Proposal for 01 series of amendments to UN Regulation No. 62 (Anti-theft (mopeds/motorcycles))

Submitted by the experts from the Working Party on General Safety*

01 series of amendments to UN Regulation No. 62 (Anti-theft (mopeds/motorcycles))

Model A

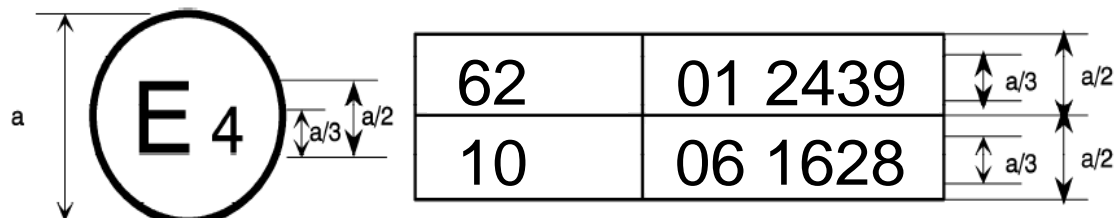
Annex 2, amend to read:

The above approval mark affixed to a vehicle shows that the vehicle type concerned has been approved in the Netherlands (E 4) pursuant to UN Regulation No. 62 and under approval number 012439. The first two digits of the approval number indicate that the approval was granted in accordance with the requirements of UN Regulation No. 62 as amended by the 01 series of amendments.
